PRODUCT CHANGE NOTIFICATION (PCN)

DK-1511-007/G MODULAR CABLE

CHANGE NOTIFICATION: PCN 20220425_DK-1511-007/G

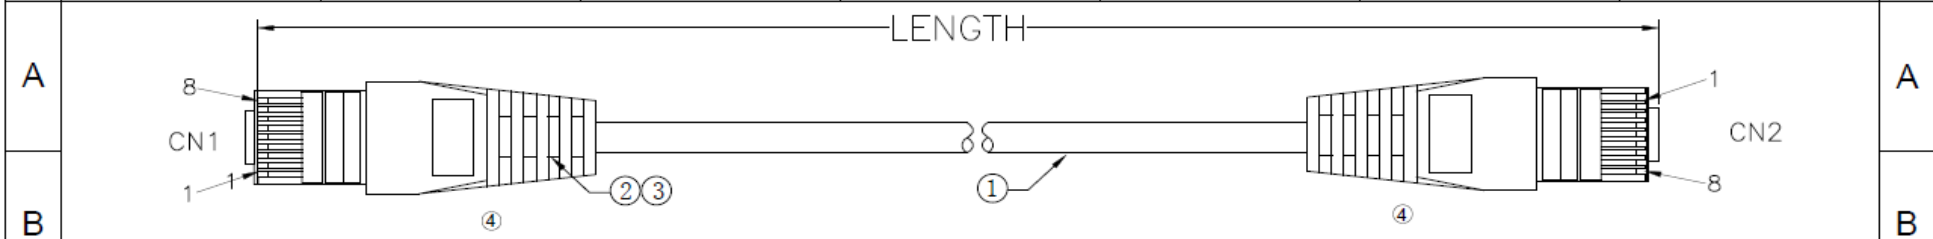
DESCRIPTION OF CHANGES: CHANGE OF DATA SHEET
CHANGE OF DATA SHEET
New Draw.-No. ASS_7160_CAreV04

REASON FOR CHANGE: CHANGE OF PRODUCT LOCATION
CHANGE OF PRODUCT LOCATION

DK-1511-007/G	OLD VERSION	DK-1511-007/G	NEW VERSION																				
<p>Appearance</p>		<p>Appearance</p>																					
<p>BOM</p> <p>SPECIFICATIONS:</p> <p>1. CONDUCTOR:</p> <p>1.1 CONDUCTORS: 24AWG 7*0.19±0.015mm</p> <p>1.2 CONDUCTOR INSULATION COLOR CODING: ONE WHITE/ORANGE, ONE ORANGE, ONE WHITE/GREEN, ONE GREEN, ONE BLUE, ONE WHITE/BLUE, ONE WHITE/BROWN, ONE BROWN.</p> <p>2. CABLE JACKET</p> <p>2.1 PRINTING ON THE JACKET: CM (UL) C(UL) 4P 24AWG UTP CAT.5E PATCH CABLE ISO/IEC 11801 & EN 50288 & ANSI/TIA-568-C.2</p> <p>3. CABLE ASSEMBLY</p> <p>3.1 SEE SECTION A-A FOR DIMENSIONS</p> <p>3.2 CABLE TIE: WHITE TIE</p> <p>3.3 WIRING TIE COLOR</p> <p>3.4 CONTACT PLUG: RJ45 8P8C 3u pc UL 94V-2</p> <p>4. CABLE JACKET COLOR: ACCORDING TO CUSTOMER'S REQUEST</p>		<p>BOM</p>

④		Molding PVC	2	Molding PVC 65P	④		RJ45 CONN	2	RJ45 8P8C, contacts 3u" gold-plated Un-shielded PC UL94V-2	④		CABLE	1	CAT 5E U/UTP(24AWGx1PR)*4+PVC Jacket OD:5.2±0.3mm	NO.		NAME	Q'TY	SPECIFICATION
④		Molding PVC	2	Molding PVC 65P																			
④		RJ45 CONN	2	RJ45 8P8C, contacts 3u" gold-plated Un-shielded PC UL94V-2																			
④		CABLE	1	CAT 5E U/UTP(24AWGx1PR)*4+PVC Jacket OD:5.2±0.3mm																			
NO.		NAME	Q'TY	SPECIFICATION																			
<p>FOR DETAIL, PLEASE TAKE ATTACHED NEW DRAWING: FOR REFERENCE</p>

Order code: **DK-1511-XXX/XX**

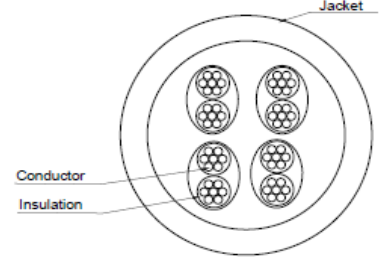
Scale	Free					Date	Name	Customer-No.
TOLERANCE		④	Change the plant	12.04.2022	Luca	Drawn	24.06.2014	Joanna
X.	±X	③	Add tolerance for cable length	20.09.2019	Amy	Approved	12.04.2022	Luca
X.XX		②	Add new length version	06.04.2017	Amy			
X.XX		①	Update length version	07.12.2016	Amy			
DIM	TOL	①	Update length version	07.12.2016	Amy			
X.°		①	Drawn	24.06.2014	Joanna			ASSMANN WSW-No. DK-1511-XXX/XX
								Drawing-No. ASS 7160 CA
Angle	TOL	Id.	Modification	Date	Name	Replace		SHEET
